FINAL  
ENVIRONMENTAL STATEMENT

INT FES 77 - 34

CORONADO  
PROJECT

Written Comments  
Received during Review of  
the Draft Environmental Statement  
and Responses

# ZONING MAP

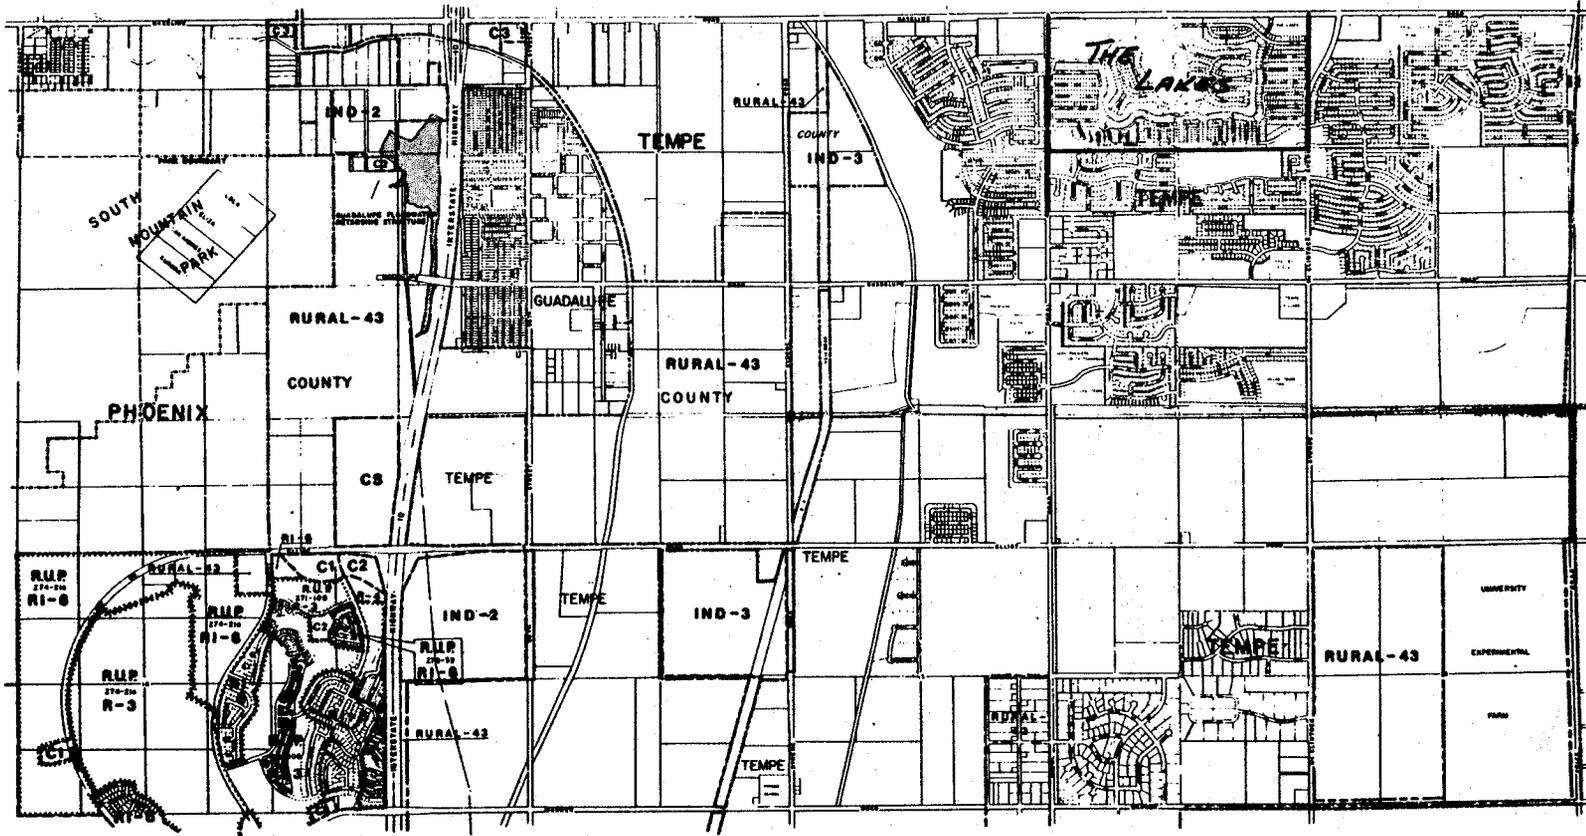
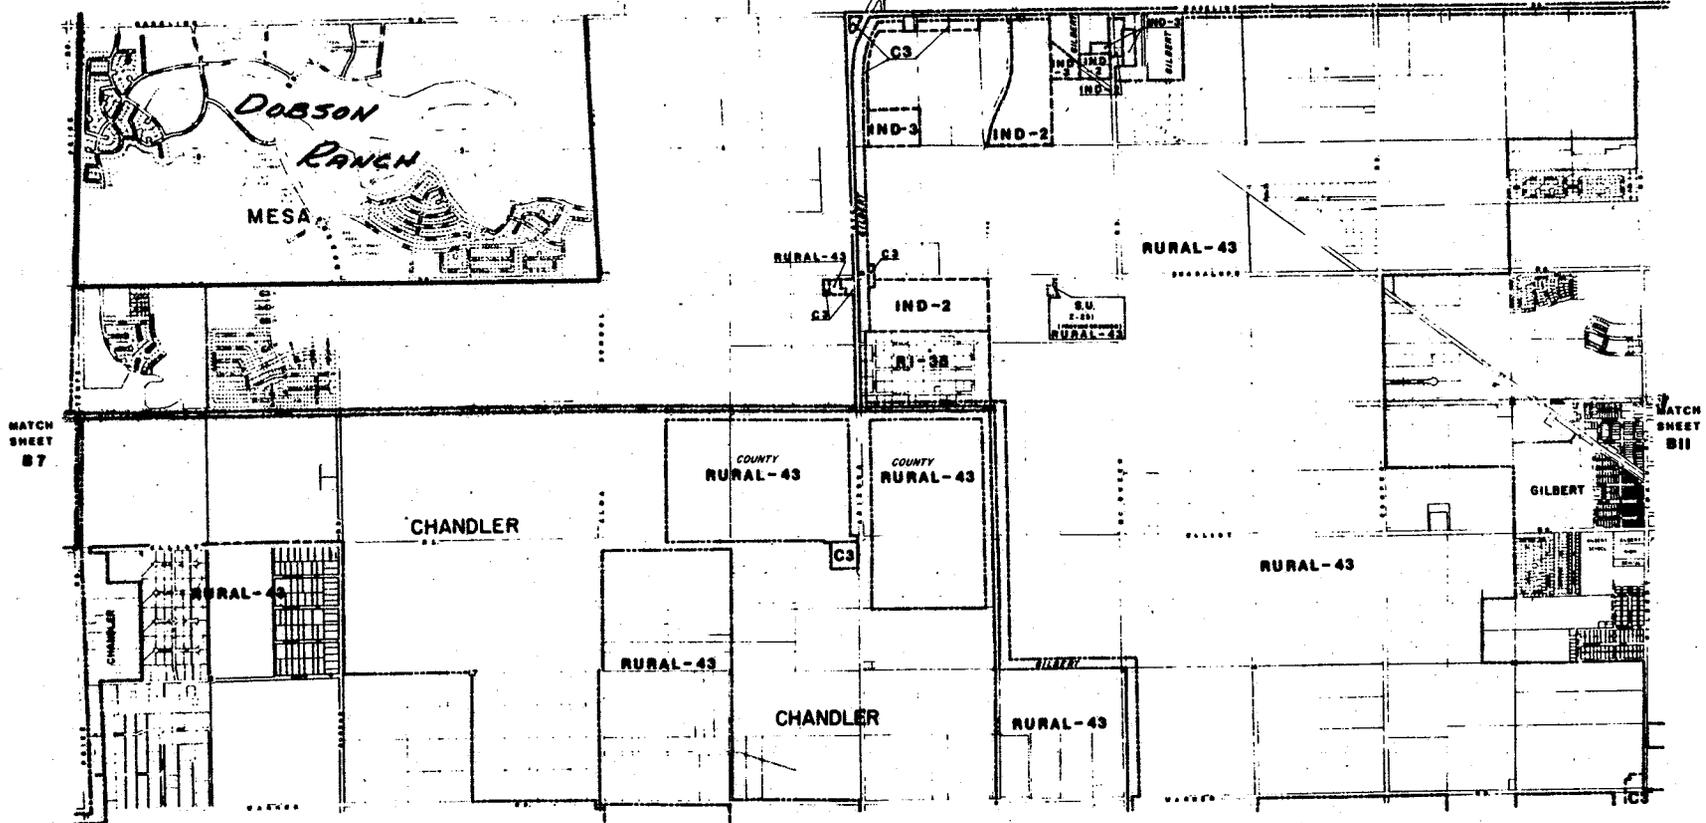
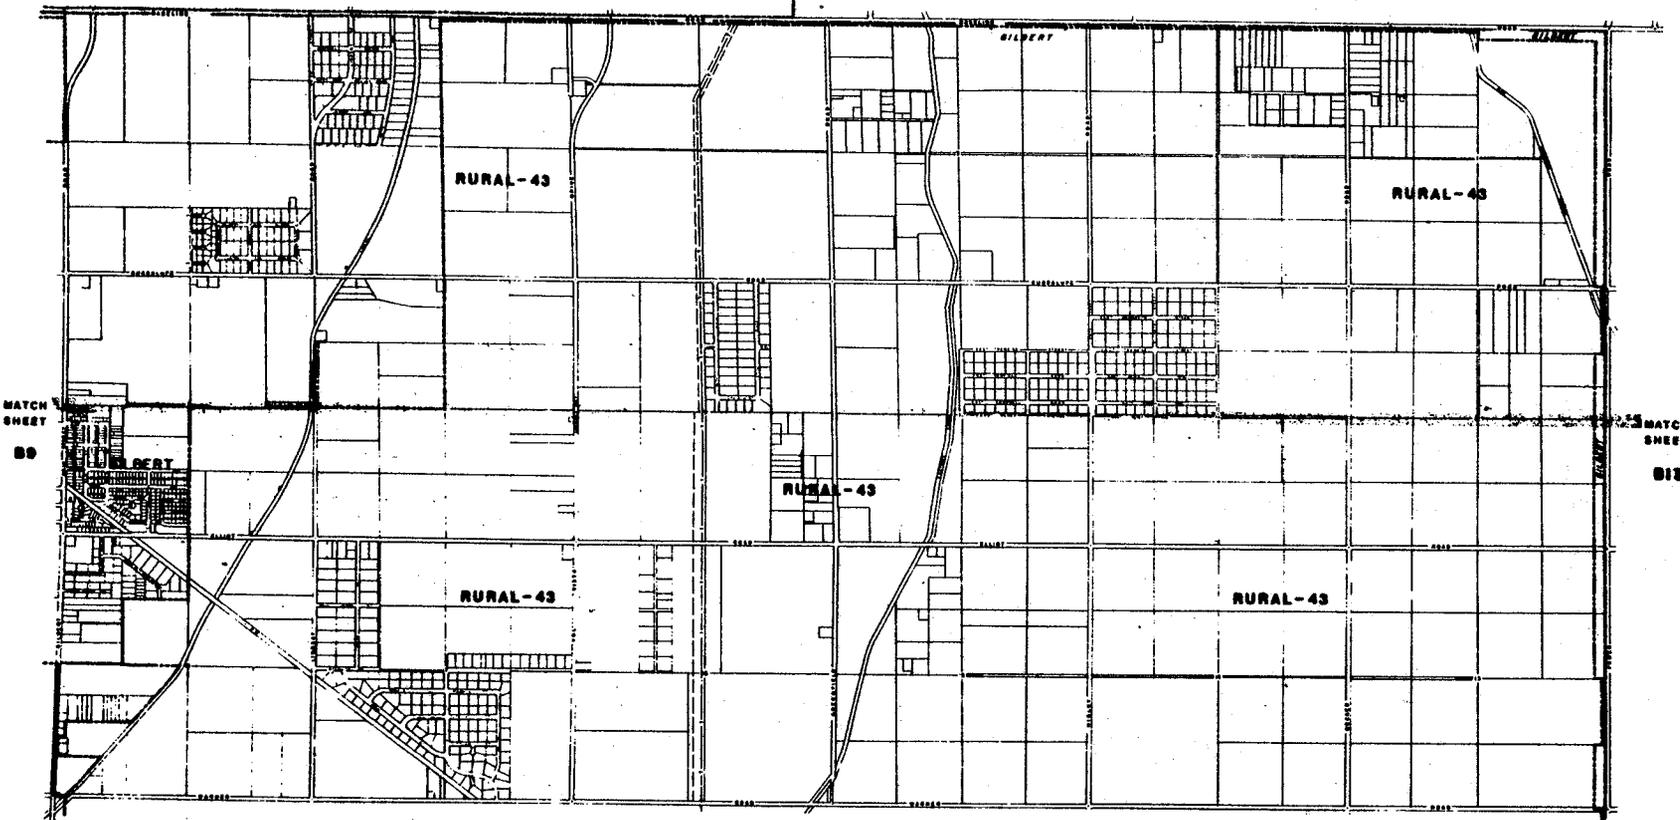
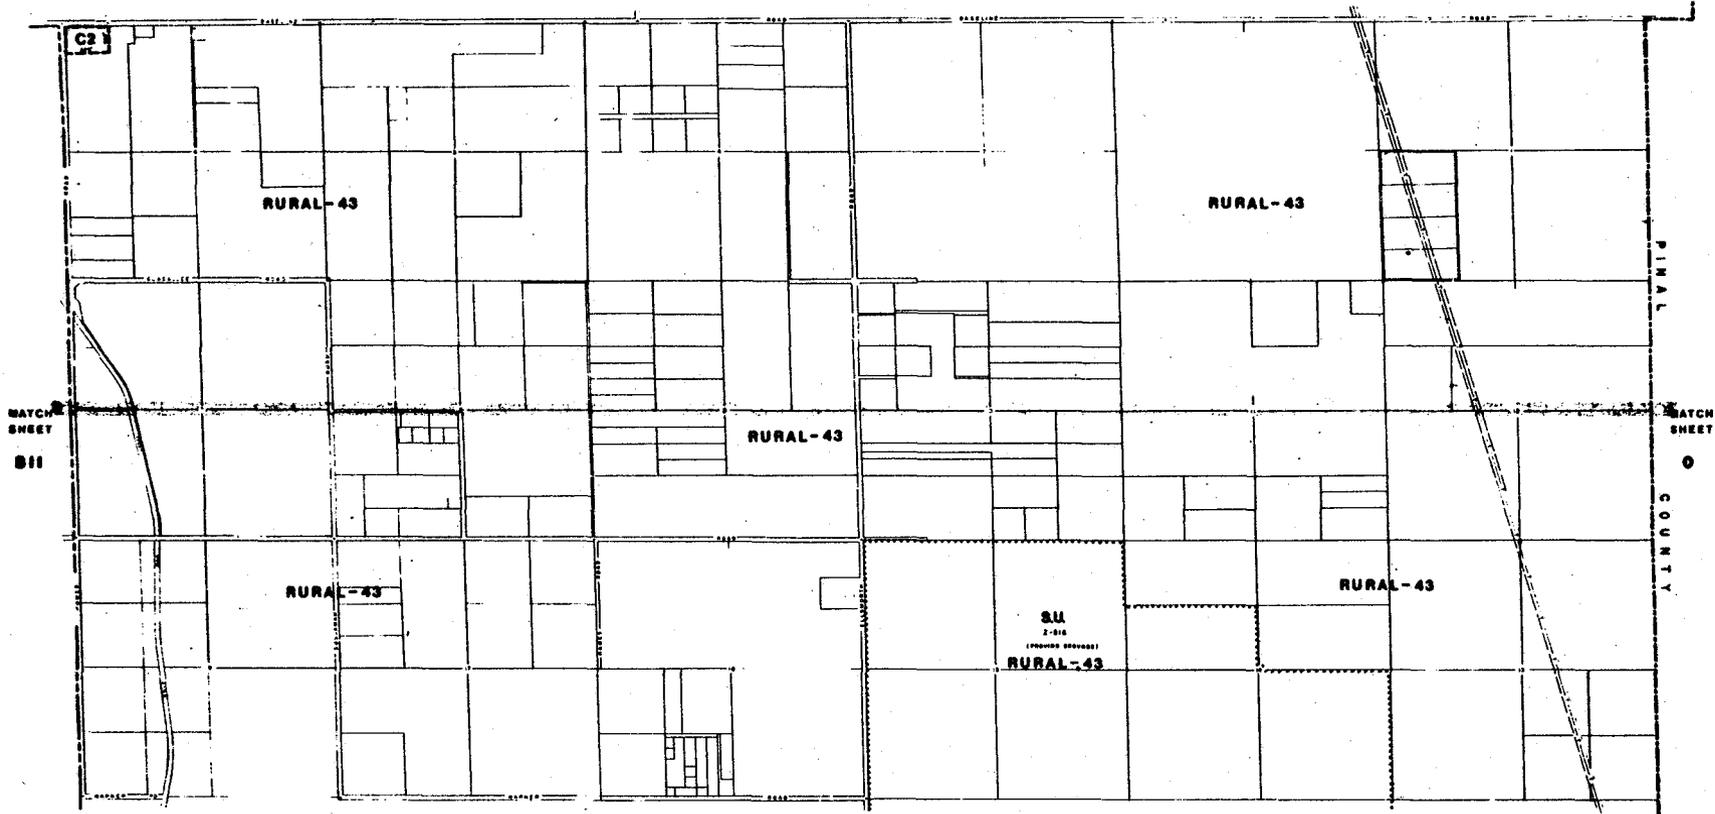
We have reviewed the Draft Environmental Impact Statement for the Coronado Project, prepared by the Bureau of Reclamation. Our only comment addresses the Kyrene Silver King 500 hv Transmission Line. This route is in close proximity to several large scale developments which are currently under construction. These developments have been located on the enclosed Zoning Maps.

We have reviewed the Draft Environmental Impact Statement for the Coronado Project, prepared by the Bureau of Reclamation. Our only comment addresses the Kyrene Silver King 500hv Transmission Line. This route is in close proximity to several large scale developments which are currently under construction. These developments have been located on the enclosed Zoning Maps.

In a telephone conversation with Frank A. Schuma, principal planner for the Maricopa County Planning Department, two large scale developments were identified. The developments are known as "The Lakes" and "Dobson Ranch". Both "Dobson Ranch" and "The Lakes" are developments with recreation facilities with golf courses, tennis courts and water. Residential areas are occupied by families in the upper middle class and higher. In "The Lakes", homes range from \$45,000 to \$150,000 with most of the homes in the \$60-\$70,000 range. "Dobson Ranch" homes range between \$40,000 and \$60,000.
